APPLICATION NO.	FILING DATE	FIRST NAMED INVENTOR	ATTORNEY DOCKET NO.	CONFIRMATION NO.
29/748,412	08/28/2020	Rahib Diwan	CIG-063US1	1778
159688	7590	06/17/2025		
Cigna - Small Patent Law Group One Express Way, HQ1 St. Louis, MO 63121			EXAMINER WHITMORE, IAN F	
			ART UNIT	PAPER NUMBER
			2923	
			NOTIFICATION DATE	DELIVERY MODE
			06/17/2025	ELECTRONIC

APPLICATION NO.	ISSUE DATE	PATENT NO.
29/748,412	17-Jun-2025	D1079708

The response received September 11, 2024 is hereby acknowledged, wherein a request for CPA was filed, accompanied by a preliminary amendment in which FIG 2 was cancelled, a replacement figure was filed showing the now sole figure of the application, and the specification was amended.

REPLACEMENT SHEET

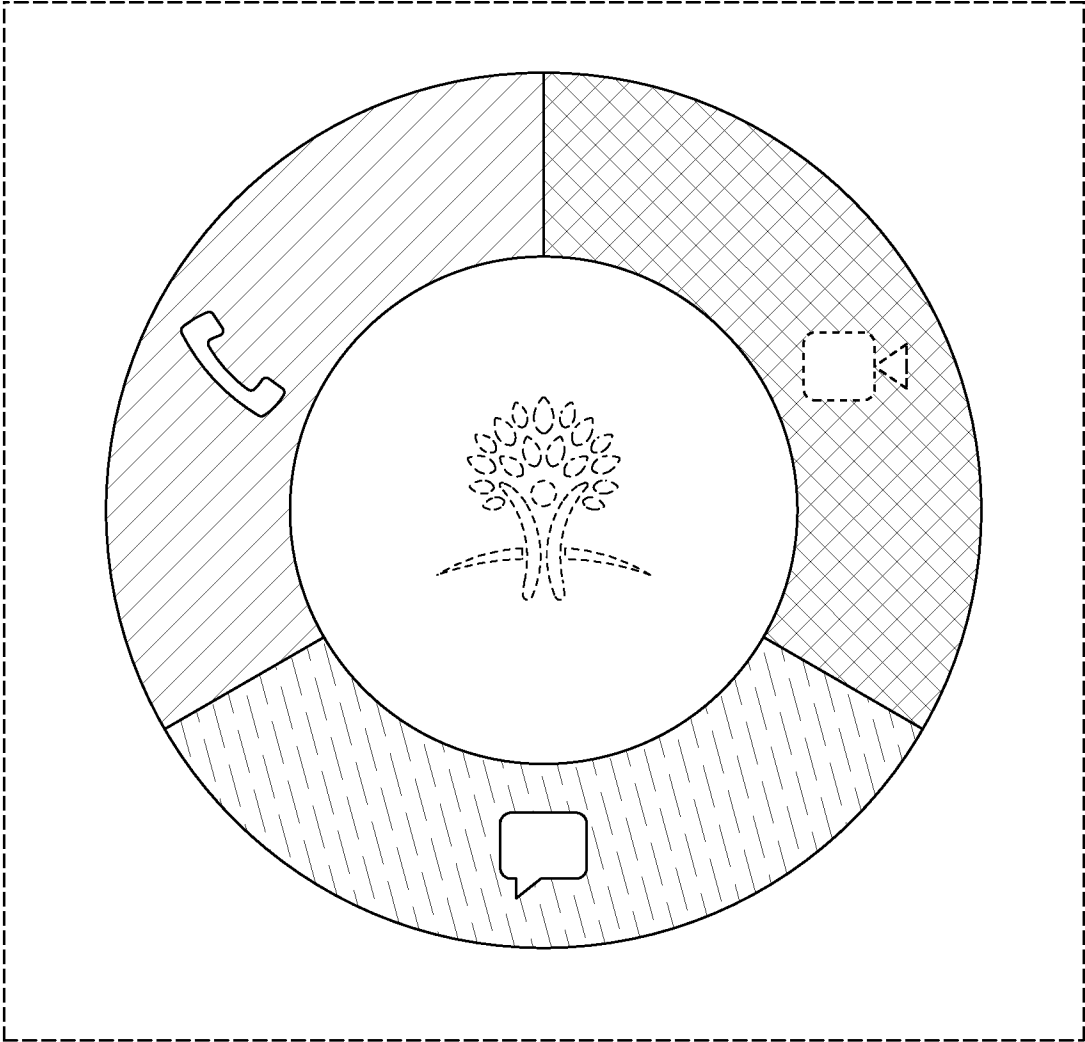
In amending the description of broken-line subject matter to account for the inclusion of the longer dashed lines in the bottom arc segment and distinguish these from “the remaining broken lines” that form no part of the claimed design, the sense conveyed by the revised language of paragraph [0003] now omits the status of the broken-line camera icon at upper right.

The meaning of broken lines shown in the drawings must be completely and accurately accounted for. See *In re Blum* 153 USPQ 177 (1967). Based on the record, the examiner understands this camera icon, like the symbol in the center of the three arcuate segments, to be intended as non-claim subject matter. Therefore, in order to fully and accurately describe what is shown in conformance with the requirements set forth in MPEP § 1503.02, paragraph [0003] must be revised to account for the status of the camera icon relative the claimed subject matter.

- The outermost broken-line rectangle illustrates an electronic display screen and forms no part of the claimed design. The broken lines illustrating the symbol in the center of the three arcuate segments and the camera icon in the upper right segment form no part of the claimed design. The differing lines patterns in the Figure illustrate a contrast in appearance. The longer dashed lines in the bottom arcuate segment of the graphical user interface illustrate a contrast in appearance and are included in the claimed design.—

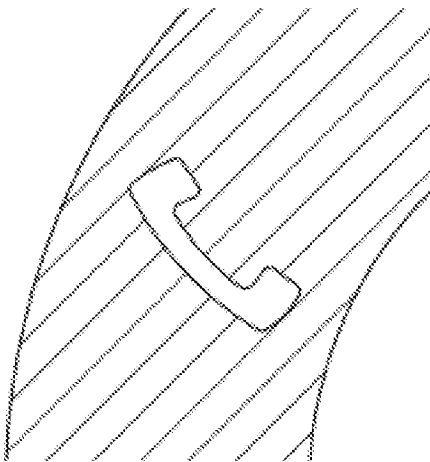
**cross-hatched
solid-line pattern
in the arc
segment at upper
right now shows
multiple lines
removed**

**telephone icon feature is shown in
solid line but is referred to in
specification as a broken-line feature,
or as having broken lines "around" it**

**central symbol is rendered *in*
broken line; no broken lines are
understood to be "around" it**

3a. Conversion of the telephone icon to solid-line subject matter raises the issue of whether previously-cited Non Patent reference "Tynan" (Document U from the 17 November 2023 Office), which includes a similar telephone icon similarly positioned, would be newly applicable as a primary reference under 103 against the revised claim. The amendment would also necessitate further search of the prior art to determine whether any secondary references teach the differences remaining between Tynan and the sole embodiment shown in the proposed replacement figure.

3b. The replacement drawing figure shows changes to the appearance of the cross-hatched line pattern at the lower right corner of the arc segment of the upper right region of the ring; specifically, multiple solid lines appear to have been removed. (See figure in attached PDF document.) Such change to the solid-line appearance of the design is unsupported by the original disclosure and would necessitate rejection for failing the description requirement under 35 USC 112(a).

**replacement
FIG 1 (detail)**

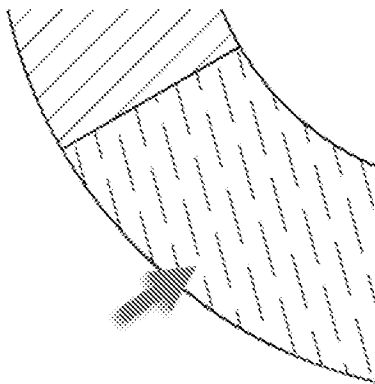
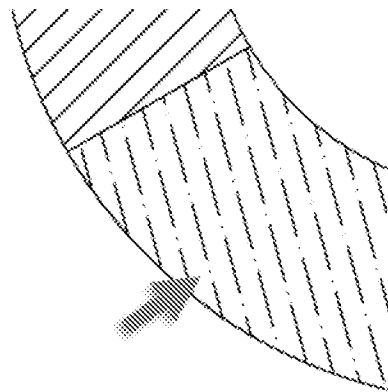
Applicant's revision of the drawings in the replacement sheets shows alteration of the appearance of the line pattern at the bottom of FIG 1 that is not supported by the original disclosure and is therefore subject to rejection as set forth below for failing the description requirement of 35 USC 112(a). Additionally, the status of this altered line pattern feature relative to the subject matter being claimed is uncertain in view of the revised descriptive

Specifically, there is no support in the original disclosure for the new appearance of the line pattern shown filling the bottom section of the ring of the radial menu feature in the embodiment shown in FIG 1. Whereas previously this line pattern was rendered in a series of long dashes, the revised pattern is shown as alternating dots and dashes. (See comparison figure above, on page 3.)

The revised FIG 1 shows a line pattern of oblique dot-dash broken lines filling the bottom third section of a ring-shaped radial menu graphical user interface feature. Although the third sentence of revised paragraph [0004] of the specification suggests that “The differing line patterns in Figure 1 illustrate a contrast in appearance” that is understood to be included as part of the intended appearance of the claimed design of the first embodiment, the second sentence of the paragraph alternatively asserts that “broken lines illustrate environment and form no part of the claimed design”. The status of the dot-dash line pattern as either claimed subject matter or a non-claim depiction of environmental context is thus uncertain due to the apparently conflicting descriptions offered by the specification.

FIG. 1

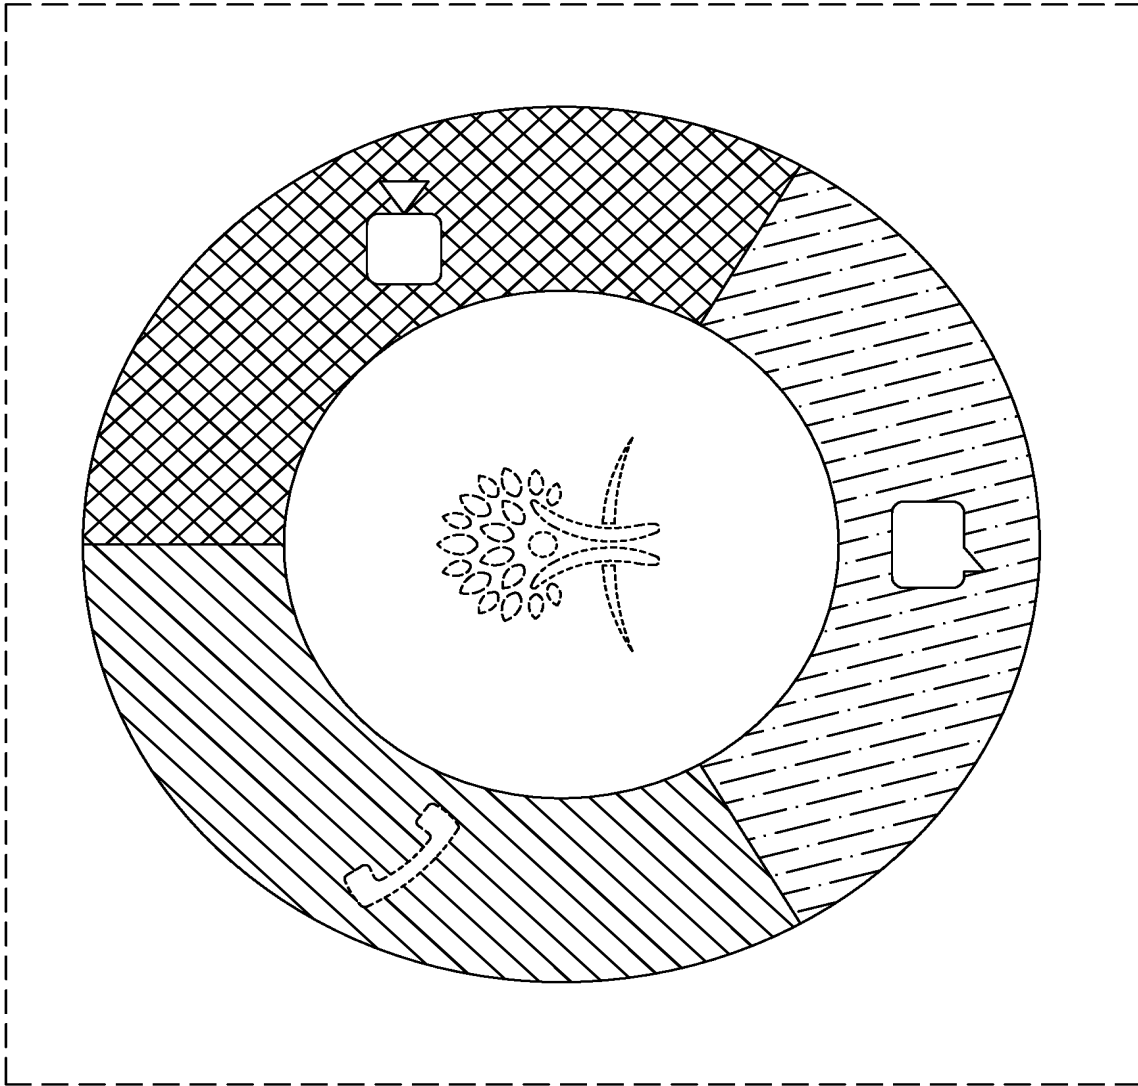
Figure 1 (now the sole Figure) is amended to revert the pattern in the bottom arcuate segment from a dash-dot pattern to a pattern formed from longer dashed lines. Additionally, Applicant has amended the specification to clarify that the pattern of longer dashed lines in the bottom arcuate segment indicate a contrast in appearance which forms part of the claimed design. Applicant submits that reverting this pattern to the prior appearance overcomes the Section 112(a) rejection as this pattern was included in the originally filed drawings.

FIG. 1

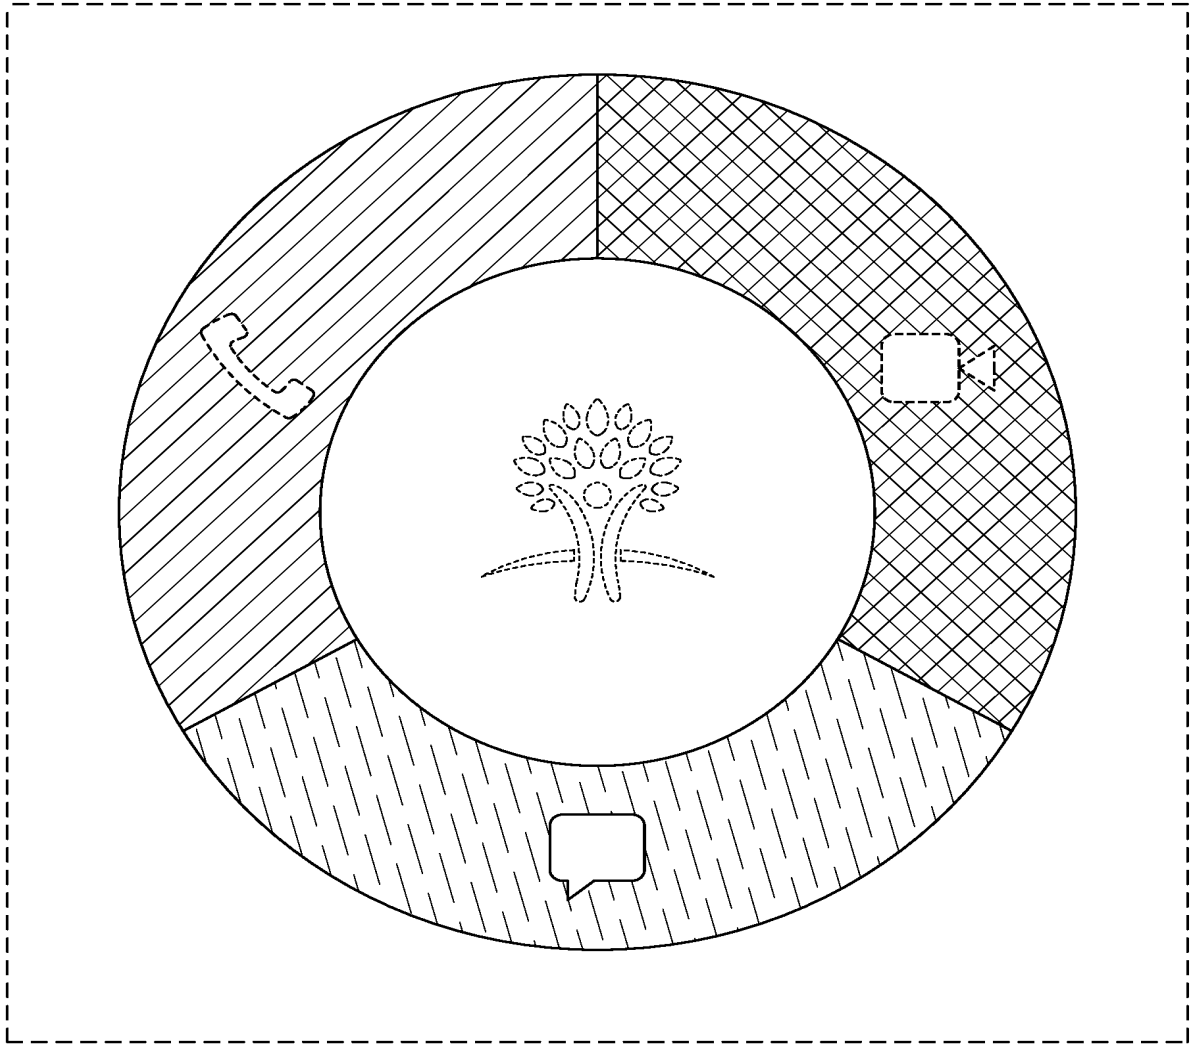
This application discloses two embodiments, shown in two separate drawing figures. Figure 1 includes portions showing linear patterns, including an arcuate section filled with oblique parallel lines, a second arcuate section filled with dashed lines arranged at a different angle, and a single third section showing cross-hatching (i.e. overlapping lines arranged at differing angles¹.)

The drawings show no color, however, paragraph [0004] includes a descriptive sentence indicating that “The cross-hatching represents potential different colors in the different parts of the icon.” This sentence makes the claim indefinite and nonenabling because it attempts to attribute unspecified visual characteristics that are not shown to the ostensibly symbolic “cross-hatching” marks that appear in one portion of FIG 1. (See rejection under 35 USC 112(a) and (b) given below.)

Figure 1 of the submitted drawings show specific line patterns but no color, and does not relate any of the line patterns to any specific colors, thus the claim is incommensurate with the scope asserted because the statement implies modifications of the design that cannot be determined from what is shown in the drawings.

The examiner notes that because the line pattern in the bottom section of the radial menu in FIG 1 employs a dashed form of line, it would be interpreted as broken-line subject matter and thus excluded from the claimed design if the revised broken line description suggested in the specification objection above were adopted. If instead the appearance of this line pattern is intended to form a part of the design being claimed in FIG 1, the specification must be amended to so indicate. A proper addition to the descriptive language of paragraph might then read:

— *The pattern of dashed oblique lines in the bottom section of the graphical user interface is included in the claimed design.* —

FIG. 2

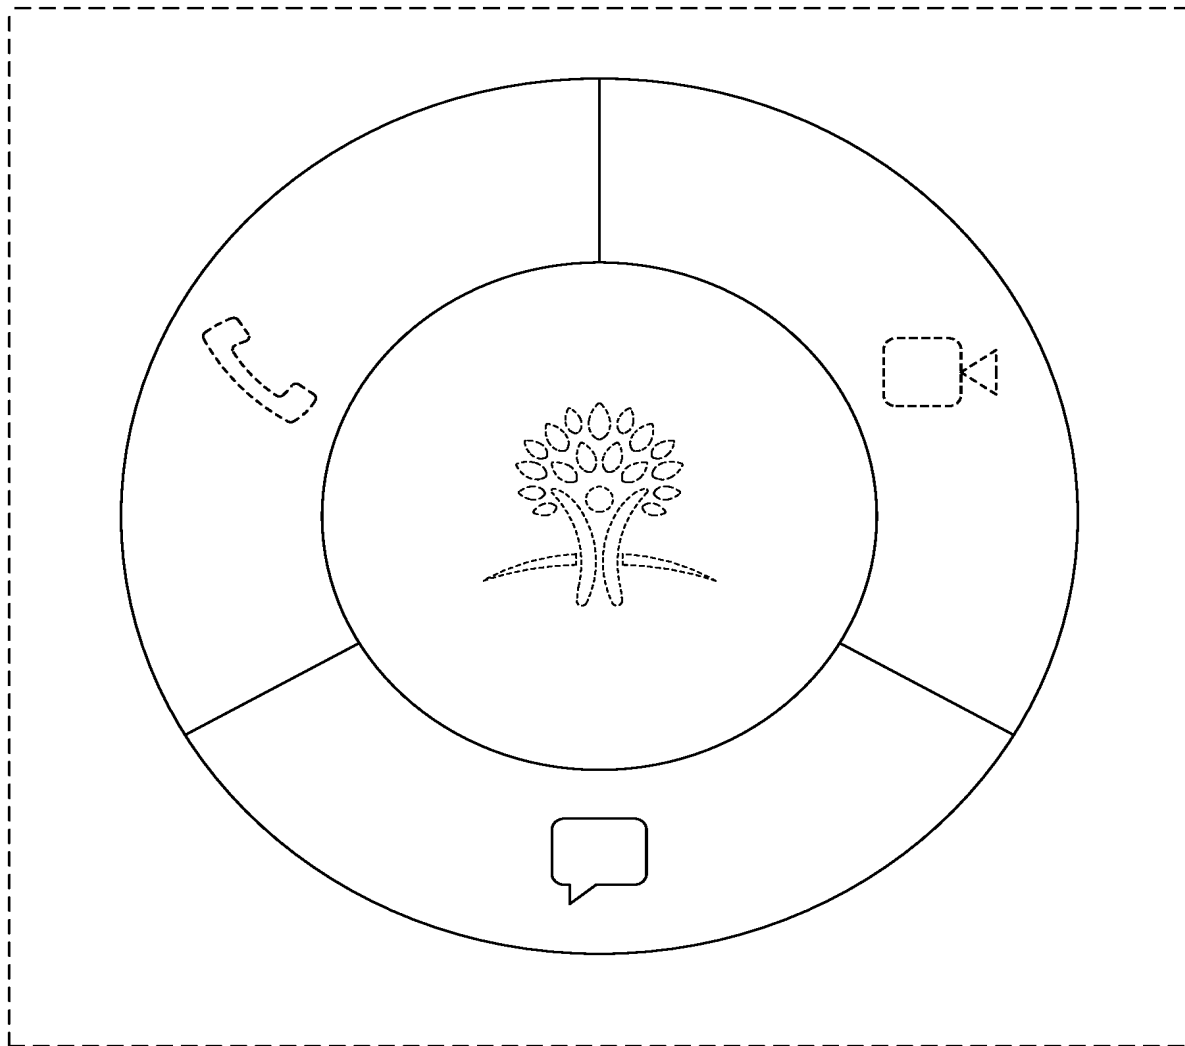
A claim involving more than one embodiment of a design concept is broad to the extent that the claim may be rejected by applying prior art against any embodiment presented as representative of the concept. See *Ex parte Appeal No. 315-40 (Wolfe et al.)* 833 O.G. 474 152 USPQ 71 (1965). In the following rejection prior art is applied against the embodiment shown in FIG 2.
